**Proposal for Amendment 5 to global technical regulation
No. 15 (Worldwide harmonized Light vehicles Test
Procedures (WLTP))**

**Submitted by the Informal Working Group on Worldwide harmonized
Light vehicles Test Procedure (WLTP)***

The text reproduced below was prepared by the Informal Working Group (IWG) on Worldwide harmonized Light vehicles Test Procedure (WLTP) in line with Phase 2 of its mandate (ECE/TRANS/WP.29/AC.3/44). The modifications to the current text of UN GTR No. 15 are marked in track changes.

Global technical regulation on Worldwide harmonized Light vehicles Test Procedures (WLTP)

Figure A1/14
Downscaled medium speed phase of the Class 1 WLTC

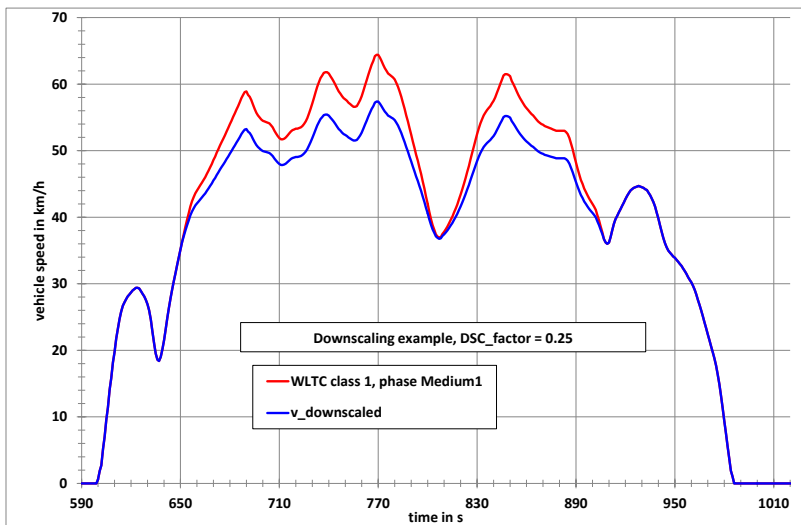
Figure A1/14 shows [an example of](#) a downscaled medium speed phase of the Class 1 WLTC.

Interpolation range for pure ICE vehicles with vehicle M

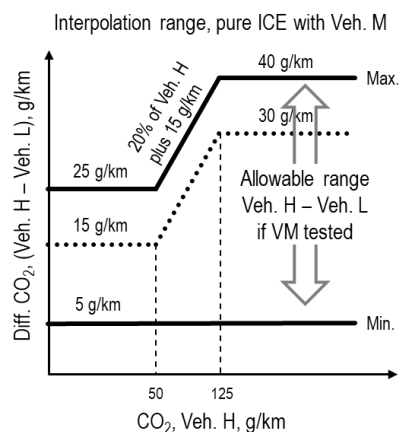
2.3.2.2.1. The allowed interpolation range defined in paragraph 2.3.2.2. of this annex may be increased by 10 g/km CO₂ (see Figure A6/3) if a vehicle M is tested

Figure A6/4
Limits for the selection of vehicle M

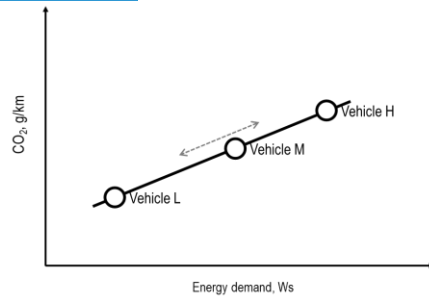
[The limits of the selection of vehicle M \(see Figure A6/4\) are such that neither the difference in CO₂ emission values between vehicles H and M nor the difference in CO₂ emission values between vehicles M and L is greater than the allowed CO₂ range in accordance with paragraph 2.3.2.2. of this annex. The defined road load coefficients and the defined test mass shall be recorded.](#)

Deleted: the interpolation line may be extrapolated to a maximum of 3 g/km above the CO₂ emission of vehicle H and/or below the CO₂ emission of vehicle L. This extension is valid only within the boundaries of the interpolation range specified in this paragraph.

Figure A8/4
Interpolation range for EVs with vehicle M

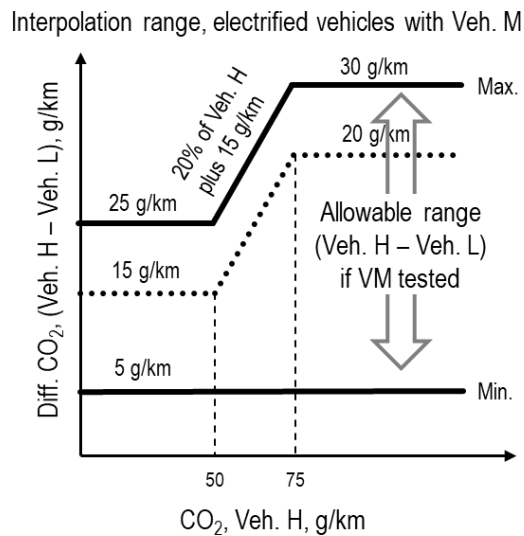
4.5.1.3. The allowed interpolation range defined in paragraph 4.5.1.2. of this annex may be increased by 10 g/km charge-sustaining CO₂ if a vehicle M is tested within that family and the conditions according to paragraph 4.5.1.5. of this annex are fulfilled. This increase is allowed only once within an interpolation family. See Figure A8/4.

Deleted: The interpolation method shall only be used if the difference in charge-sustaining CO₂ mass emission, $M_{CO_2,CS}$, according to Table A8/5, step No. 8 between test vehicles L and H is between a minimum of 5 g/km and a maximum of 20 g/km or 20 per cent plus 5 g/km of the charge-sustaining CO₂ mass emission, $M_{CO_2,CS}$, according to Table A8/5, step No. 8 for vehicle H, whichever value is smaller.

Figure A8/5
Limits for the selection of vehicle M

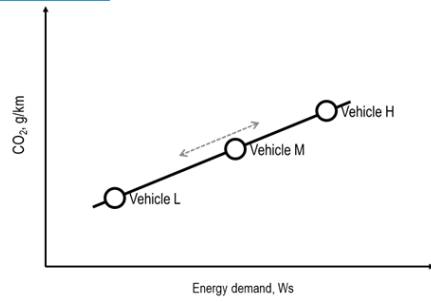
The limits of the selection of vehicle M (see Figure A8/5) are such that neither the difference in CO₂ mass emission between vehicles H and M nor the difference in charge-sustaining CO₂ mass emission between vehicles M and L is higher than the allowed charge-sustaining CO₂ range according to paragraph 4.5.1.2. of this annex. The defined road load coefficients and the defined test mass shall be recorded.

Deleted: The maximum absolute boundary boundaries of the interpolation range specified in this paragraph 20 g/km charge-sustaining CO₂ mass emission difference between vehicle L and vehicle H or 20 per cent of the charge-sustaining CO₂ mass emission for vehicle H, whichever is smaller, may be extended by 10 g/km if a vehicle M is tested. Vehicle M is a vehicle within the interpolation family with a cycle energy demand within ± 10 per cent of the arithmetic average of vehicles L and H.¶
